PCN 18_0036

ADGM1304 Data Sheet Changes

Rev.D to Rev.E

This document highlights the changes from the Rev. D to the Rev. E data sheet for the ADGM1304 SP4T MEMS switch with integrated driver.

Figure 3 Typical Operating Circuit for ADGM1304 Rev D

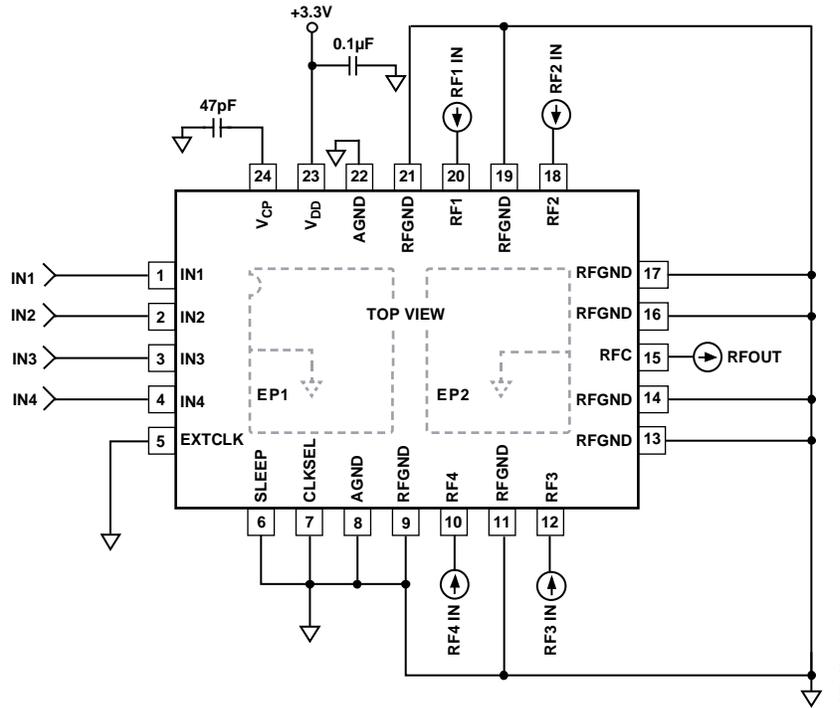
Figure 3 and Figure 4 outlines the typical operating circuit comparison of the Rev. D to Rev. E material. There are no changes to typical operating circuit in parallel mode for both Rev D and Rev E material.

Figure 4 Typical Operating Circuit in Parallel Mode for ADGM1304 Rev E

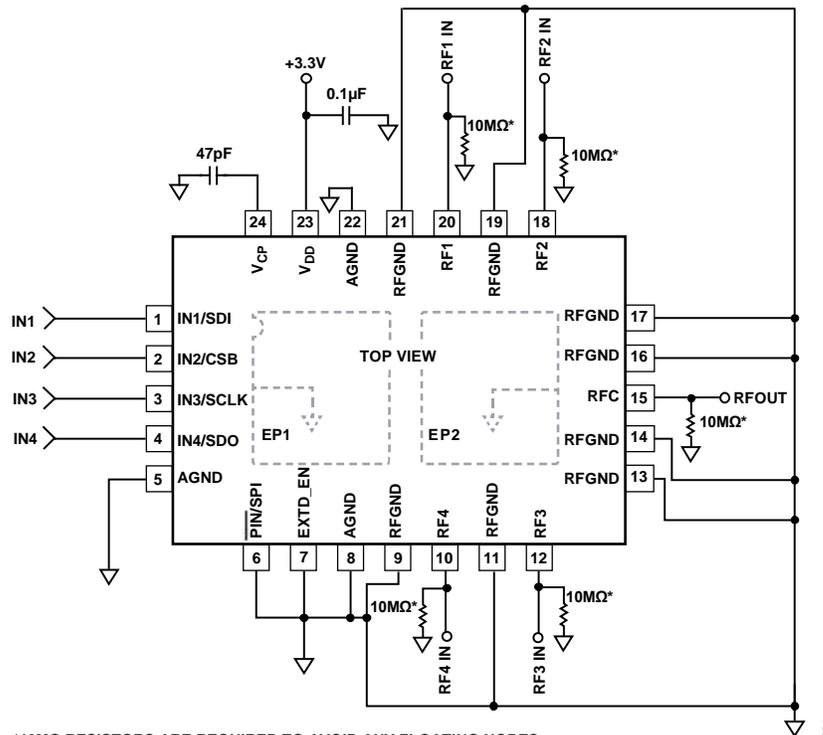
*10MΩ RESISTORS ARE REQUIRED TO AVOID ANY FLOATING NODES.
FOR MORE INFORMATION, REFER TO THE APPLICATIONS INFORMATION SECTION

Figure 6 50 Ω system representation where the ADGM1304 is connected with the load

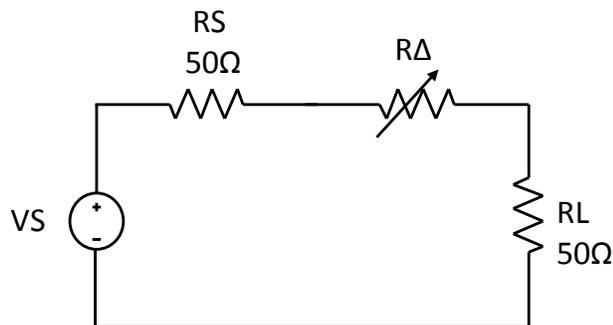
ADGM1304 Ron varies over time and over actuations. In a 50 Ω system, the on-resistance drift over switch actuations can introduce system inaccuracy. Figure 5 shows ADGM1304 connected with the load in a 50 Ω system. The system error caused by ADGM1304 RON drift can be calculated by equation(1)

The ADGM1304 RON drift also effects insertion loss which need to be considered. The on-resistance impact on insertion loss can be calculated by the equation (2)
